WARNING

FRM31825 Revised 11/14 Printed in U.S.A.

Figure 3

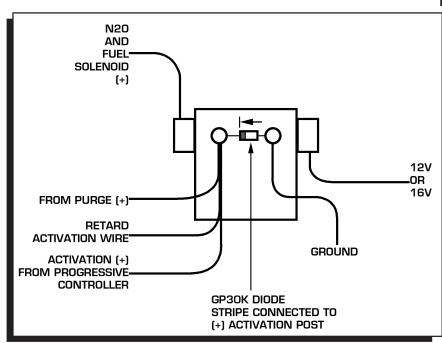
Switching from high current activation relays over to solid state relays will also prevent damage to the retard circuits. Refer to the Figure 3 for instructions to properly install the diode onto the relay(s) without affecting the response time of the nitrous/fuel solenoids and a nitrous controller.

This can result in permanent damage to the circuit board and will render the step retards useless. MSD Recommends diode suppressing the relays by using the diodes provided in the parts bag. One diode is provided for each step retard activation wire (Figure 2).

Note: Diode is rated at 800V/3A.
